**CONTRACT DOCUMENT
BOONE COUNTY, MISSOURI
Liberty Lane Road Reconstruction Project
Bid Number 06-17FEB04**

ADDENDUM # 1

SECTION 01570 – EROSION CONTROL

SILT FENCE
Not to Scale

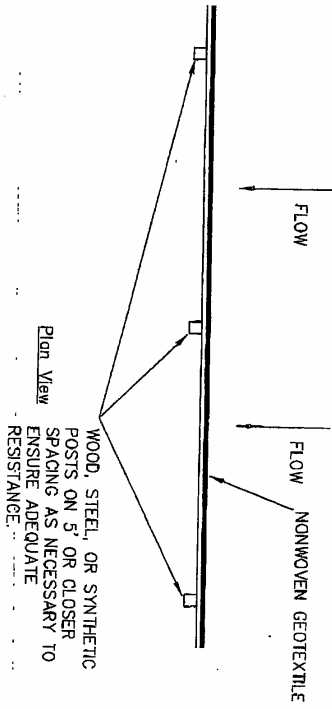
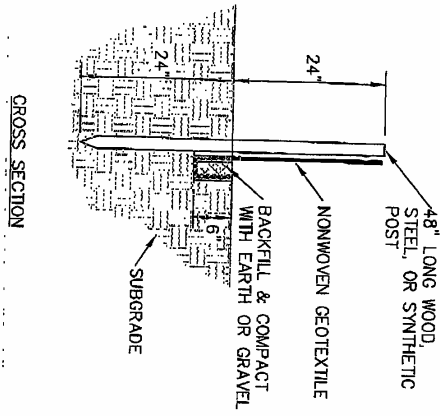
EROSION CONTROL PLAN – SHEET 27 OF 29

REPLACE: SILT FENCE DETAIL with attached SILT FENCE DETAIL
